THE APPLICATION OF BARKLEY LAKE WATER)
DISTRICT, (1) FOR A CERTIFICATE THAT)
PUBLIC CONVENIENCE AND NECESSITY RE-)
QUIRES THE CONSTRUCTION OF NEW PLANT)
FACILITIES; AND (2) SEEKING APPROVAL) CASE NO.
OF THE ISSUANCE OF CERTAIN SECURITIES;) 8937
AND (3) FOR AN ORDER AUTHORIZING AD-)
JUSTMENT OF WATER SERVICE RATES AND)
CHARGES)

R E P O R T

RE: Case No. 8937
Review of the engineering hydraulics submitted
by Barkley Lake Water District

FIGURE 1

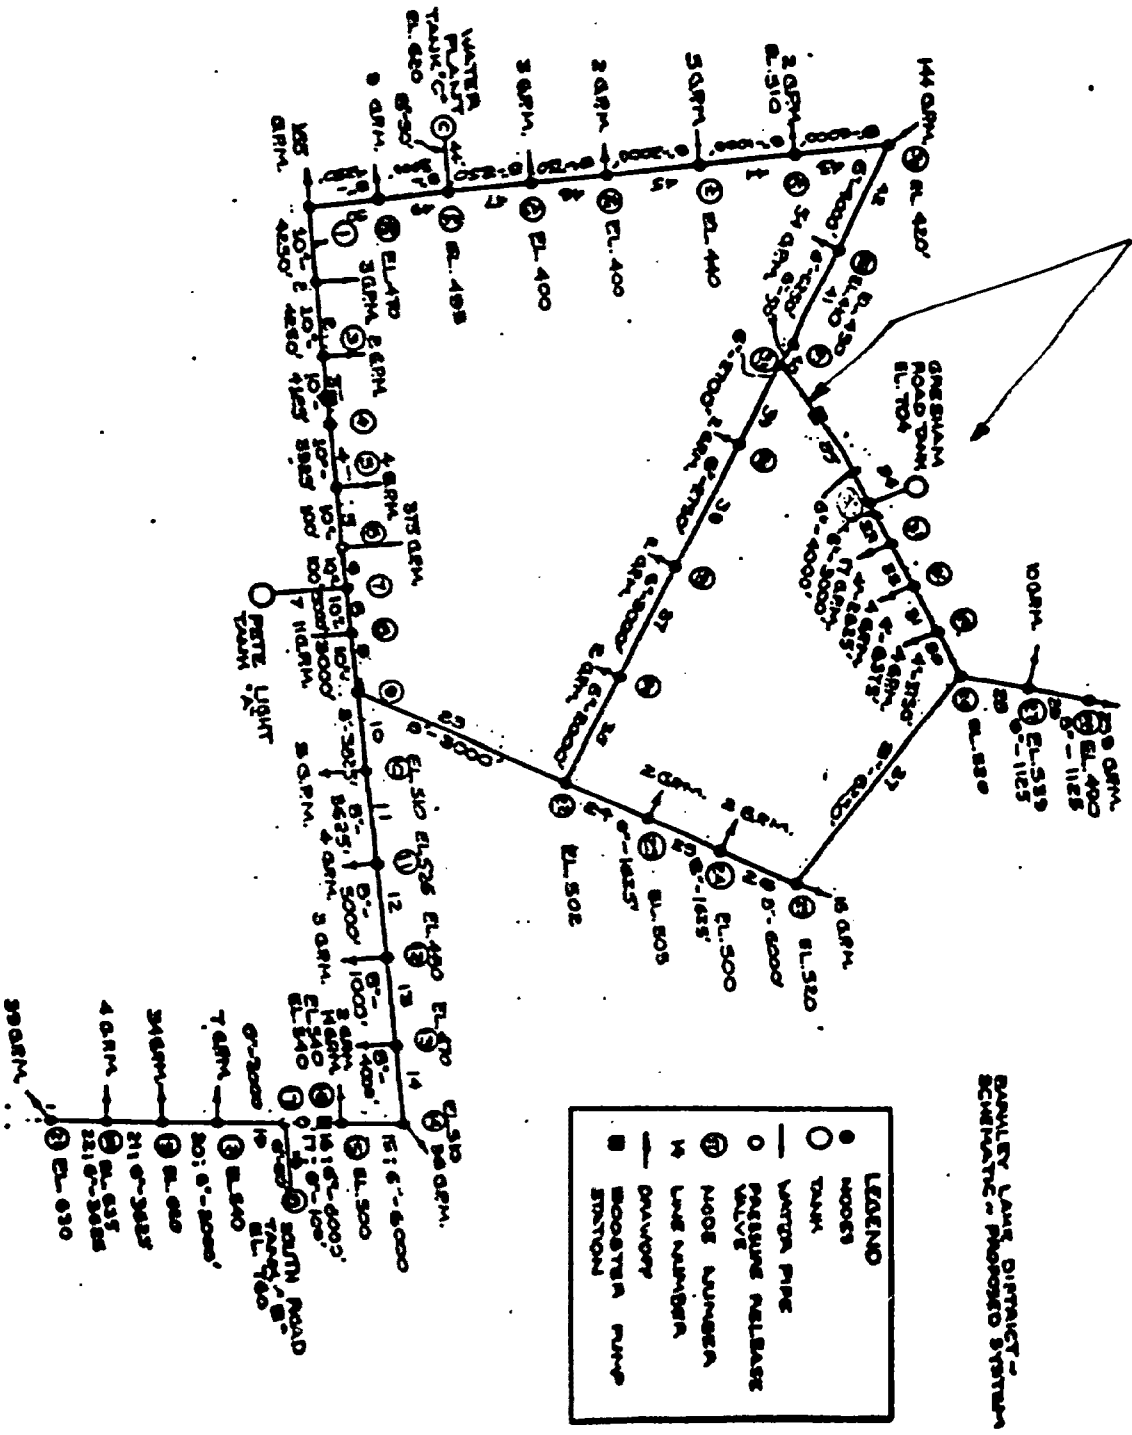
The purpose of this report is to discuss the engineering data and hydraulic calculations presented by the Barkley Lake Water District ("Barkley Lake") to justify its proposed construction of a 450,000-gallon standpipe near Cadiz, Kentucky. On November 13, 1983, the Public Service Commission received an application from Barkley Lake for approval of the construction of a 450,000-gallon steel water storage tank and approximately 8,750 linear feet of 6-inch diameter water pipeline and a booster pump station with 2-150 gallon per minute pumps. Also included with Barkley Lake's petition was a request for approval of a financing plan and a request to increase rates to its customers.

distribution system includes a water treatment plant, 4 storage tanks, and about 286 miles of pipeline (See Figure 1). The 4 storage tanks: a 250,000-gallon elevated tank at the water treatment plant, a 200,000-gallon standpipe near Pete Light Springs Road, a 150,000-gallon storage tank near Cerulean and a 50,000-gallon elevated storage tank near South Road provide a total of 650,000 gallons of storage. However, after subtracting the minimum tank level requirements, we find that only 420,000 gallons of this storage can be considered as useful storage. Water in storage below minimum levels will not provide minimum requirements for service pressure.

While it is not abundantly clear that the computer model is in fact calibrated, let's assume for the sake of argument that it is. We then need to compare the existing system hydraulic analysis with the proposed system hydraulic analysis to check for the effects of the new construction. There are four noticeable points when comparing the proposed system to the existing system. They are as follows: (1) The Pete Light tank fills under peak demand on the proposed model and empties under peak demand on the existing model. (2) The proposed tank can be filled under peak demand with the proposed pump in operation, (3) It is hydraulically closer from the existing tank at the water treatment plant to the area of the proposed construction such that demand for water has been shifted from the Pete Light tank to the tank at the water treatment plant, and (4) The pressure at several points on the system is actually lower after the improvements are made according to the computer model. This apparently occurs due to operation of the proposed pump. The most noticeable drops in pressure occur around the area of the Lake Barkley State Resort Park and the area of last summer's water outage. Lake Barkley State Resort Park which has its own pumps and tank, can reportedly put a very large demand on Barkley Lake's system and can also cause low pressure

The problem with reviewing only the operating scenarios filed is that we do not know how the new tank is going to function when the proposed pump is off which would be expected sometime during the day. In order to verify that the proposed tank is going to be "used and useful," this information is mandatory.

Another noticeable problem with the information filed is that the specifications require 2 pumps each capable of delivering 150 gallons per minute at 185 feet total head with 10 HP motors. However, with the proposed pump operating the computer model at one point shows the proposed pump delivering about 189 gallons per minute at 230 feet total head. Since the proposed tank is full the flow delivered by the proposed pump would be at a minimum due to the higher head involved in pumping to a near full tank. As such, when the tank is less than full the proposed pump would deliver more water against the lesser head. If the computer model is correct and a pump with the operating point of 189 gallons per minute at 230 feet total head has to be used, the pump specified would not work because it would be near what is known as "shut-off head." At "shut-off head" there is no flow. Based on the above, either the model is wrong or the pump specified was not properly selected. Possibly the pumps are operating in parallel but this was not stated. This would still lead to the same conclusions, however.

(1) Barkley Lake's application for a certificate of public convenience and necessity should be denied.
